Access Compliance Report

Public Rights-of-Way

(Curb Ramps)

Intersection ID: 17612	Main Street: ASHCRAFT LN	Cross Street: PARK_RD	Location: NW
ADA ID: FCAFADE393FC	Ramp Type: BlendTrans2	Initial Pass/Fail: Fail	Overall Compliance: No
Severity Score: 25			
Codes/Mitigation Info/Possible Solution		Field Measurements/Component Compliance

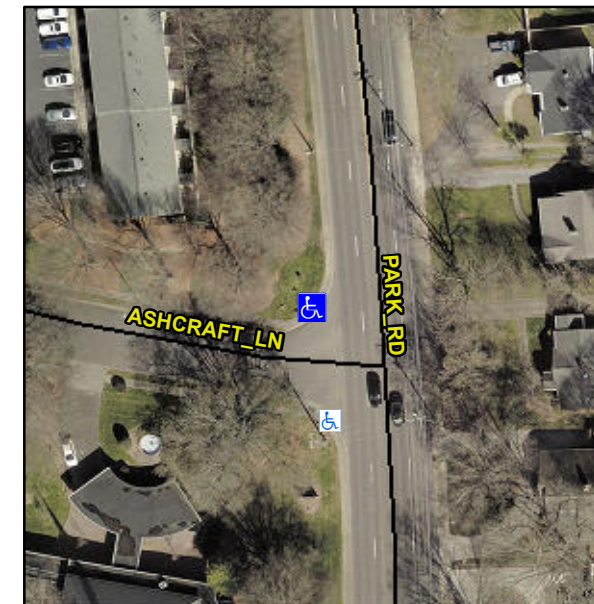
Not Found, R304.5.3

Compliance	Description	Data	Compliance	Description	Data
N/A	Ramp Length (in)	48.0	Yes	BlendTrans Slope (%)	4.6
Yes	Ramp Width (in)	48.0	No	BlendTrans XSlope (%)	8.7
N/A	Flare Type LT	N/A	N/A	Flare Type RT	N/A
N/A	Flare Slope LT (%)	N/A	N/A	Flare Slope RT (%)	N/A
N/A	Flare Traversable LT?	N/A	N/A	Flare Traversable RT?	N/A
N/A	Landing Length (in)	N/A	N/A	DWS Provided?	N/A
N/A	Landing Width (in)	N/A	N/A	DWS Contrast?	N/A
N/A	Landing Slope (%)	N/A	N/A	DWS Length (in)	N/A
N/A	Landing X Slope (%)	N/A	N/A	DWS Full Width?	N/A
N/A	Landing Curb? (Y/N)	N/A	N/A	DWS Offset (in)	N/A
N/A	Shared Landing?	N/A			
N/A	Gutter Ponding?	N/A	N/A	Gutter Slope (%)	N/A
N/A	Gutter Lip Ht (in)	N/A	N/A	Gutter X Slope (%)	N/A
N/A	Painted X Walk1?	No	N/A	Painted X Walk2?	No
	X Walk 1 Direction	To S		X Walk 2 Direction	To E
	X Walk 1 Width (in)	N/A		X Walk 2 Width (in)	N/A
	X Walk 1 Slope (%)	2.4		X Walk 2 Slope (%)	2.1
	X Walk 1 X Slope (%)	2.4		X Walk 2 X Slope (%)	0.1

N/A	Ramp inside XWalk1?	N/A	N/A	Ramp inside XWalk2?	N/A
	Road Slope (%)	4.6		Clear Space?	N/A
	Road X Slope (%)	1.7	N/A	Clear Space to XWalk (in)	N/A
N/A	Any Obstructions?	N/A	N/A	Storm Grate/Utility Hazard?	N/A
	Obstruction Type			Storm Grate/Utility Type	
		N/A			N/A
			Yes	Surface Condition? (G/P)	Good
			No	Curb Slope (%)	17.0

Remove & Replace Curb Ramp With Two New Directional Ramps or Equivalent.
